Staff Report & Recommendation

Design Review Board

SUBJECT: DRB18-0322
4354 Alton Road – NORTH PARCEL

DATE: February 05, 2019

Sec. 142-106. - Setback requirements for a single-family detached dwelling.

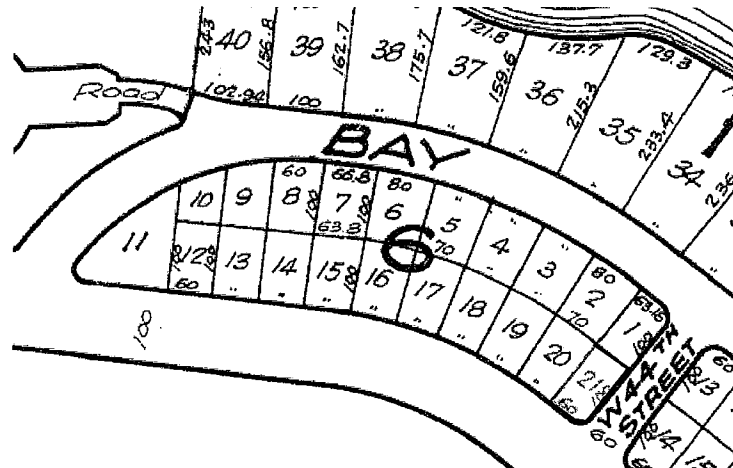
1. A variance to reduce by 10'-0" the minimum required front setback of 30'-0" for a two-story single-family home in order to construct a new two-story residence at 20'-0" from the front (east) property line facing Alton Road.
 - Variance requested from:

One-story, detached structures have a minimum front setback requirement of 20'-0" but any portion of a two-story home must be setback an additional 10'-0". In this design, both floors are setback 20'-0" from the front property line.
